VIRGINIA ELECTRIC AND POWER COMPANY
SURRY POWER STATION UNITS 1 AND 2
PROPOSED LICENSE AMENDMENT REQUEST
ALLOWED OUTAGE TIME EXTENSION FOR REPLACEMENT OF RESERVE
STATION SERVICE TRANSFORMER C 5KV CABLES TO TRANSFER BUS F
RESPONSE TO REQUEST FOR CLARIFICATION AND ADDITIONAL INFORMATION

RESPONSE TO NRC REQUEST FOR ADDITIONAL INFORMATION

**REQUEST FOR ADDITIONAL INFORMATION
REGARDING ONE-TIME 14-DAY ALLOWED OUTAGE TIME
FOR REPLACEMENT OF 5 KV CABLES ASSOCIATED WITH
RESERVE STATION SERVICE TRANSFORMER C**

Figure 1

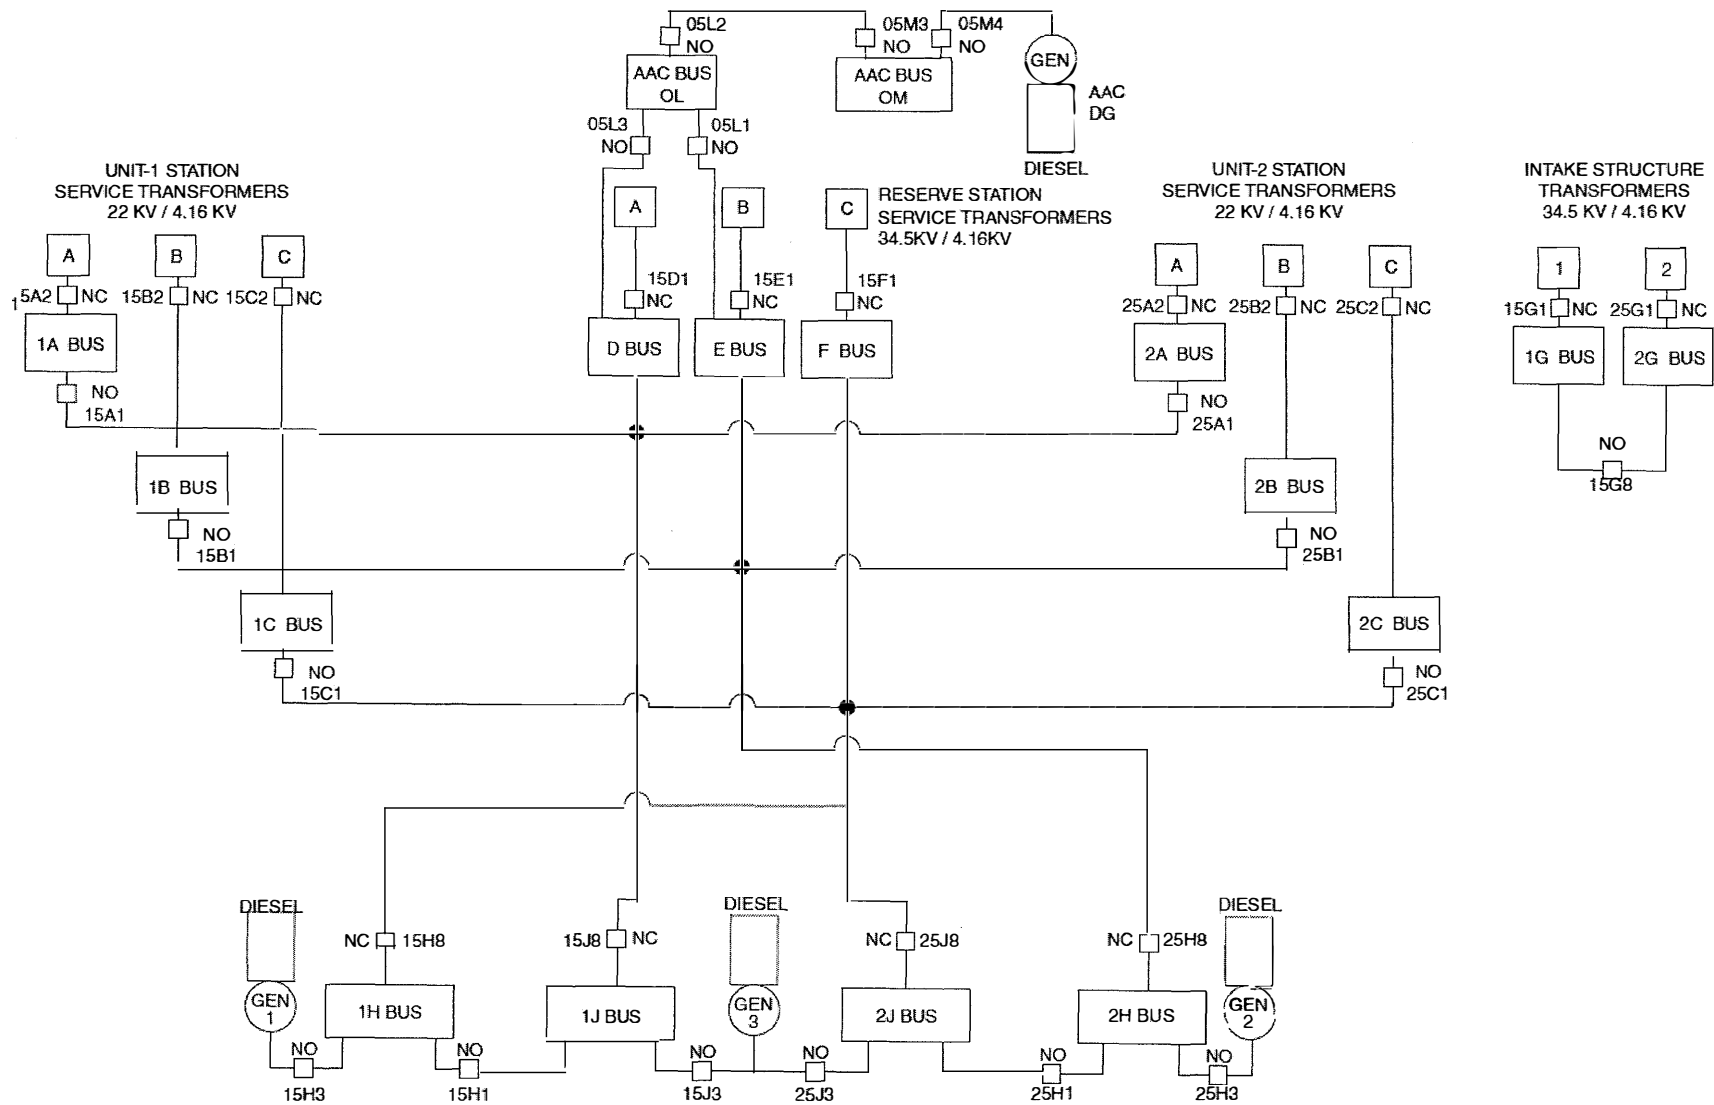
Please provide a detailed description of the functions of the (1) Two Unit Load Shed Circuit (LSR1), and (2) Auto Start Blocking Circuit (LSR2). Also, explain why the operating restrictions on these circuits are considered necessary during the temporary 14-day AOT.

Explain why the operating restrictions on these circuits are considered necessary during the temporary 14-day AOT.

The primary concern in the plant load shed design is overload of the RSST and transfer bus electrical distribution system. If a breaker (15A2, 15B2, or 15C2) from a Station Service Transformer (SST) to the normal station service unit bus trips automatically, an automatic transfer to the RSSTs occurs if no fault exists on the normal station service bus. The automatic transfer is accomplished by closure of Breakers 15A1, 15B1, or 15C1. (See Figure 1.) The affected normal station service bus is then supplied from the RSST through the transfer bus. The transfer bus continues to connect the RSST to the emergency buses to ensure continuous service for the safety-related equipment.

During the automatic transfer, voltage transients and bus overloading may occur. This is particularly true in the event of two-unit loading on the transfer buses. The load shed scheme reduces the electrical loading on RSS Transfer Buses D, E and F during events that necessitate two-unit simultaneous loading on an individual transfer bus. Per the Surry UFSAR (Chapter 8, Section 4.1), "To include the possibility of two-unit simultaneous loading of the reserve station service (RSS) system, within its design capability, a load shedding system is installed to remove the overloads on the RSS system. This system provides for automatic load shedding of selected non-safety-related loads from both units which limits RSST loading to under 4000A per transformer...". Sensing relays detect when both units' station service feeder breakers from an RSS transfer bus are closed. The actuating relays then send tripping signals to specific loads. The tripping signal trips specified running equipment and defeats the auto-start capability of non-running equipment.

To alleviate potential low-voltage profile conditions of the Vital and Emergency Electrical Distribution System during a Safety Injection (SI) or Consequence Limiting Safeguards (CLS) actuation, an automatic start inhibit or blocking circuit is installed. When initiated, the auto-start blocking circuit sends signals to specific pieces of equipment based on the position of the associated bus feeder and defeats the auto-start capability of non-running equipment. The auto-start block circuit ensures sufficient power supply capacity and voltage levels for emergency equipment. Per the Surry UFSAR (Chapter 8, Section 4.1), "The automatic starting of selected large non-Class 1E loads is blocked. The loads that

are prevented from auto starting are the condensate, bearing cooling, and component cooling pump motors. The auto-start block will remain in effect for 60 seconds following an SI signal and 315 seconds following a CLS signal. This feature will prevent any voltage degradation of the emergency buses as a result of starting of the non-Class 1E loads...".

The auto-start inhibit or blocking function described in the Surry UFSAR will function as intended, i.e., there are no new operating restrictions being imposed on this function. The Two Unit Load Shed Circuit is conservatively defeated during the 14-day AOT to avoid any inadvertent actuation of the circuitry while performing cabling installation at the transformer and the "F" transfer bus. This action is appropriate because the logic circuit for load shed is partially made-up when the shutdown unit is on the dependable alternate source (backfeed), which will be the case when the cable replacement is performed. With the refueling unit on backfeed, the refueling unit having reduced load, and RSST C out of service, there is no need for the load shed.
